# Work Order ID **94343**

Item Name: Crosstube Assembly, Mid Aft

DRAWING NO. D206-667-247  
REV. A  
SHEET 1 OF 4

| DRAWING NO.<br>D206-667-247 | TITLE<br>CROSSTUBE ASS'Y (206L MID AFT) | REV. A                  | <b>DART AEROSPACE LTD<br/>ENGINEERING ORDER</b> |  | D.E.O. NO.<br>D206-667-247-A-1 | SHEET NO.<br>SHEET 1 OF 1 | SCALE<br>NTS |

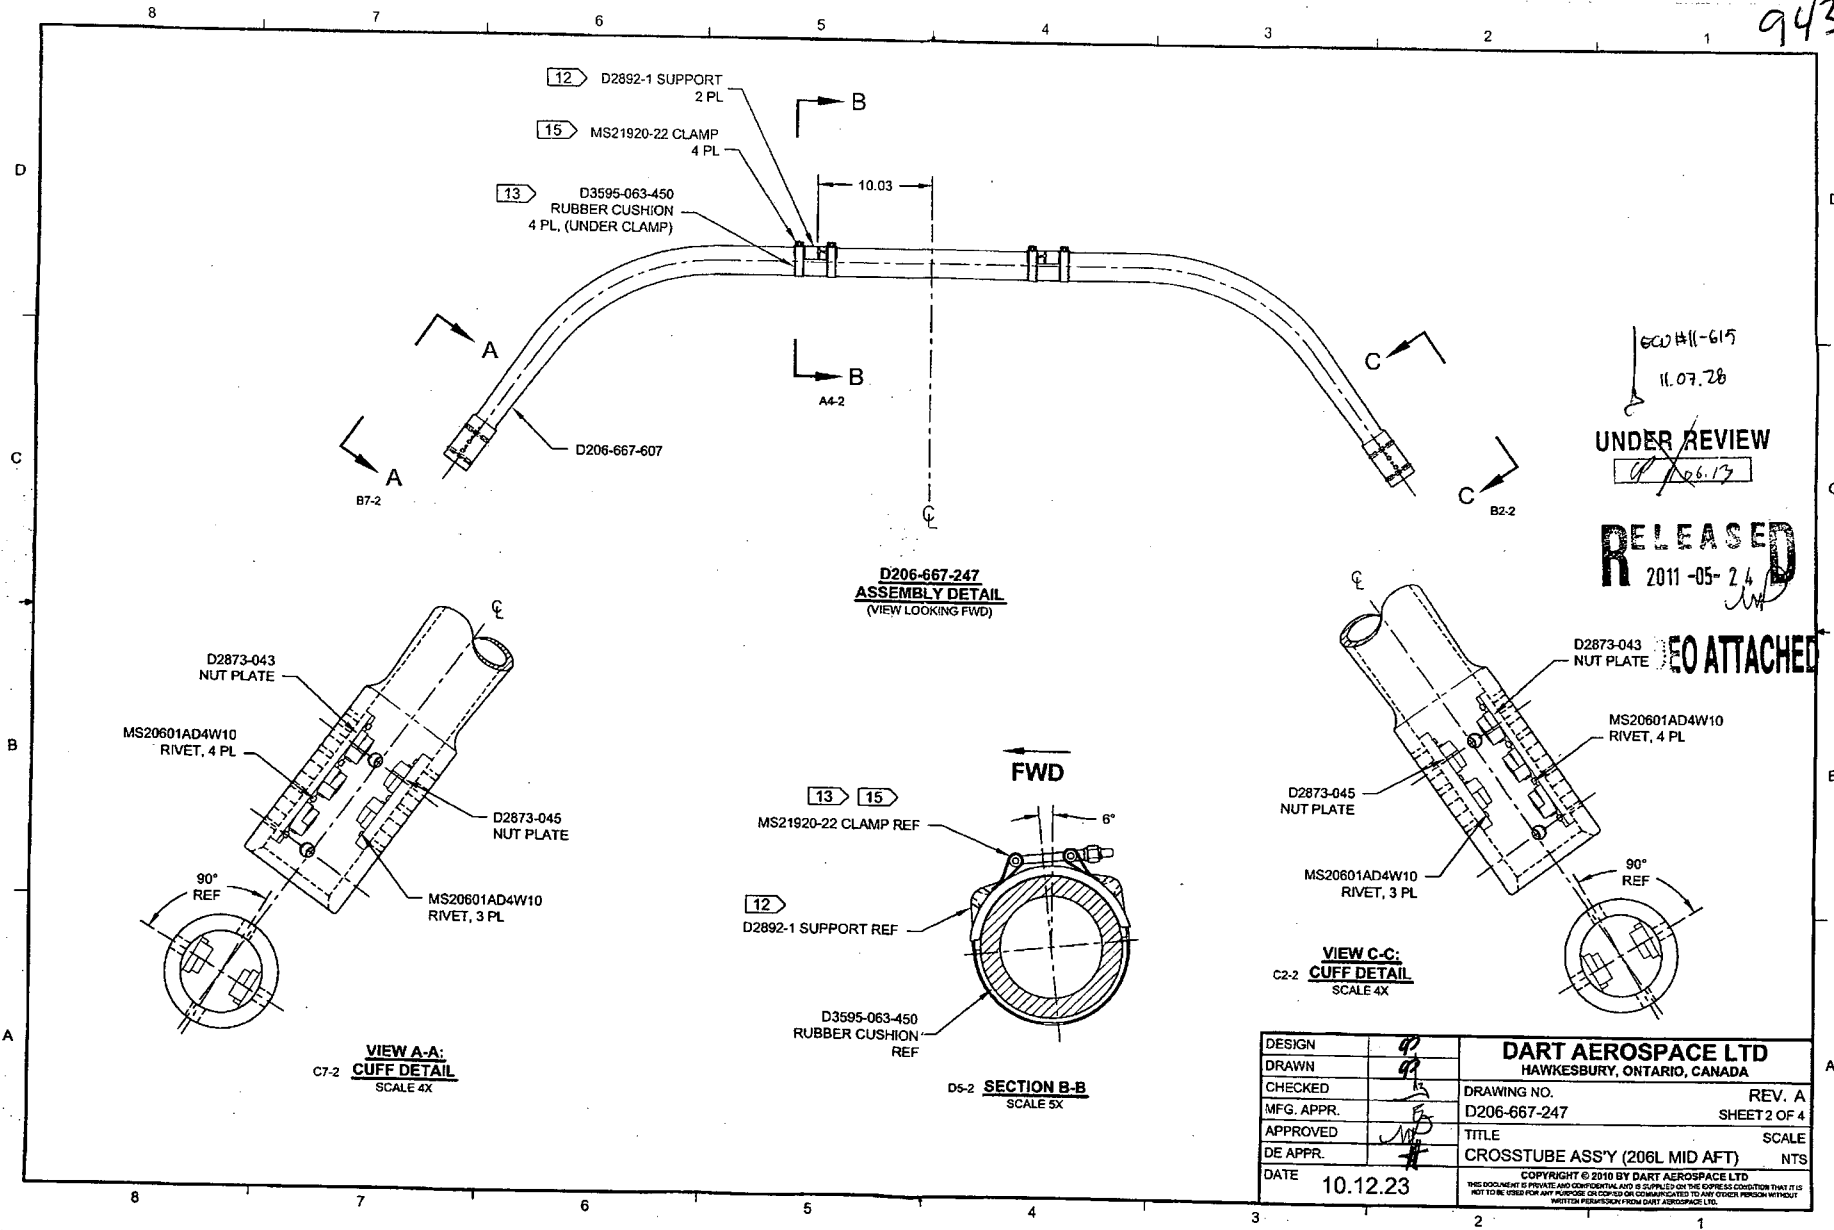
**PURPOSE:**

REPLACE MAGNOBOND WITH PROSEAL.

NOTE 12 & 15, SHEET 1 IS AMENDED AS FOLLOWS:

IS:

| Item | Qty<br>-247 | Part Number     | Description                   |
|------|-------------|-----------------|-------------------------------|
| 9    | A/R         | PROSEAL 890 B-2 | SEALANT, AMS-S-8802 CLASS B-2 |

- 12) TO INSTALL D2892-1 SUPPORT: ABRASE MATING SURFACE OF SUPPORT AND CROSSTUBE WITH 180-GRIT SANDPAPER AND REMOVE RESIDUE WITH MEK (OR EQUIVALENT). APPLY A 0.04" TO 0.07" THICK LAYER OF PROSEAL 890 CLASS B-2 (OR AMS-S-8802 CLASS B-2) SEALANT TO MATING SURFACE OF SUPPORT.
- 15) TORQUE CLAMPS 80 TO 100 IN-LB. ENSURE AT LEAST 1.5 THREADS SHOWING IN SAFETY AND THAT NUT HAS NOT BOTTOMED-OUT AFTER TORQUING. **PRIOR TO PACKAGING, RE-CHECK TORQUE ON CLAMPS AFTER PROSEAL 890 SEALANT HAS CURED FOR 72 HOURS.**

WAS:

- 12) INSTALL D2892-1 SUPPORT USING 0.03" TO 0.06" THICK LAYER OF MAGNOBOND 6398 PER QSI 015. LET CURE FOR 12 HOURS AFTER INSTALLATION AND PRIOR TO PACKAGING.
- 15) TORQUE CLAMPS 80 TO 100 IN-LB. ENSURE AT LEAST 1.5 THREADS SHOWING IN SAFETY AND THAT NUT HAS NOT BOTTOMED-OUT AFTER TORQUING.
